Request for Additional Information No. 406(4683, 4664, 4707), Revision 0

U. S. EPR Standard Design Certification

SRP Section: 09.02.02 - Reactor Auxiliary Cooling Water Systems

09.02.02-112

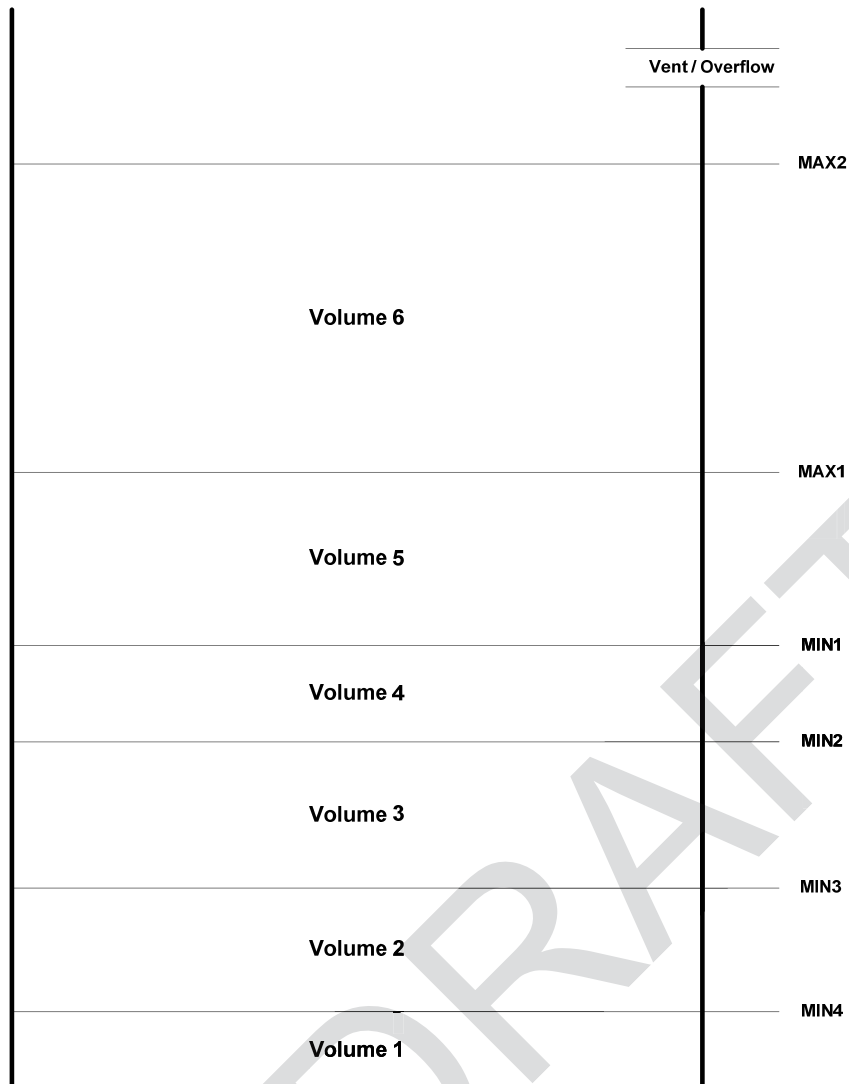
Part (c)1 and (c)2: In Part (c)1 of follow-up RAI 9.2.2-67 the applicant was asked to provide justification for the assumed 1 gpm leak rate and to consider the need to account for leakage through large diameter closed switchover valves. For Part (c)2 the applicant was asked to similarly consider the impact of any revised leak rate from (c)1 on volume loss from the tank until the initiation of emergency makeup. In response the applicant identified a revised position that assumed leakage of 5 gpm through each of four closed switchover valves (2-24" and 2-16" diameter valves) for a total of 20 gpm per train. This equated to an one hour surge tank leak rate of 1200 gallon.

As previously identified in RAI 9.2.2-107 (4644/17637), the staff concluded that the use of a NSR/ Seismic Category II surge tank makeup water source is inconsistent with guidance provided in SRP 9.2.2 paragraph III.3C for a safety related seismic makeup source. Accordingly, the applicant needs to specify that the makeup water source is safety related, seismic category I. The applicant should also identify the flow rate and water volume that is available from the finally selected makeup source to confirm that the requirements of the CCWS system can be met. Based on a 20 GPM loss for valve seat leakage only for 7 days 201,600 gallons is required for make-up for one train.

- a. Describe the surge tank level at the start of the scenario knowing that the non-safety make-up starts to make-up at MIN1 (if available) as described in Tier 2 FSAR Section 9.2.2.6.1 and that the non safety users isolate at MIN2 (based on delta flow) and switchover valves do not isolate until MIN3 is reached in the surge tank.
- b. For Item (C)2, describe the basis for total required makeup volume for 7 days and that continuous outleakage must be assumed for the 7 day period as discussed in SRP 9.2.2.
- c. The applicant should also discuss pump seal and valve packing leakage.

Part (c)1, (c)2, (c)3 and (c)4: A review of the CCWS design confirmed that the emergency post-seismic makeup from the Seismic II Fire Water Distribution System is not required. The primary means to satisfy NRC Standard Review Plan Section 9.2.2, Section 3C guidance will be the retention of a reserve volume in each CCWS surge tank to accommodate 7 days of leakage.

A review of the CCWS design confirmed the assumed valve seat leakage of 5 gpm for isolated portions of the system that resulted in the need for post-seismic makeup was conservative. This value was based on the ASME OM Code ISTC-3630 - Leakage Rate for Other Than Containment Isolation Valves, Part (e) which states "If leakage rates are not specified by the Owner, the following rates shall be permissible: (1), for water, 0.5D gal/min (12.4d ml/sec) or 5 gal/min (315ml/sec), whichever is less, at functional pressure differential".

For the CCWS, the assumed leakage paths are through each of the (2) 16" Common "a" header isolation valves and the (2) 24" Common "b" header isolation valves. Pump seal leakage and miscellaneous valve packing leakage is also considered for each CCWS train. The leakage rate for the CCWS valves will be based on ASME QME-1-2007 for flow control valves that are also intended to serve as isolation valves. Operational Experience will be included in the design of the surge tank volumetric allotment for post-seismic leakage in addition to code calculated valve seat leakage rates. ASME QME-1-2007 identifies a low leakage rate of 0.1 in.³/hr/NPS of nominal valve size and a nominal leakage rate of 0.6 in.³/hr/NPS of nominal valve size. Assumed pump seal leakage of 100 cubic centimeters per hour and miscellaneous valve packing leakage of 250 cubic centimeters per hour is included in the leakage calculation for each train. The following table summarizes the total train leakage and the total required volume to accommodate continuous leakage for 24 hours/day for 7 days when the nominal rate of 0.6 in.³/hr/NPS of nominal valve size is applied. For valve seat leakage, the worst case pressure delta resulting from one CCWS train in service with the associated train for the same common header depressurized is considered.

The CCWS surge tank volume and level design is as shown in the figure below.

To set the levels for operating volumes in each surge tank, the following considerations are applied:

- Normal Operating level is between MIN1 and MAX1
- Normal Demineralized Water makeup initiates at MIN1
- Non-Safety users outside of the Reactor Building automatically isolate at MIN2
- Common Header Switchover valves automatically isolate at MIN3
- CCWS Pump trip is at MIN4
- The minimum water level in any CCWS surge tank is calculated per ANSI/HI 9.8 (1998). This level is used to determine Volume 1 for each tank. Volume 1 will vary by tank due to slight variations in dimensions for each tank.
- Volume 2 between MIN3 and MIN4 is a water volume equal to 750 gallons per tank. This is the Post-Seismic 7 day leakage volume. This volume of water between MIN3 and MIN4 allows a CCWS train to run for 7 days on safety injection cooling with no surge tank make-up
- Volume 3 between MIN2 and MIN3 is equal to the system fluid lost during automatic isolation of a pipe rupture.

- Setting MIN1 level in each tank will provide Volume 4. Volume 4 will vary by tank due to varying sizes for each tank.
- Volume 5 is an open space volume allocated for thermal expansion of the CCWS system fluid.
- Volume 6 is an open space volume allocated for in-leakage from a HX tube rupture and offer time for operators to diagnose the malfunction and take action.

Per SRP 9.2.2, III, 3.C time zero for consideration of this post seismic leakage value begins at the low level alarm. For the CCWS design, the low level alarm in the tank is MIN3. MIN3 is the level at which “time zero” begins. At MIN3, seat leakage through the isolation valves for the non-safety related users is not a concern because those valves isolate at MIN2. Those valves are inside of the boundary created by closing the switchover valves at MIN3. Accounting for this post-seismic leakage allowance between MIN3 and MIN4 provides the CCWS with adequate capacity to operate for 7 days without reaching the MIN4 level which trips the CCWS pump.
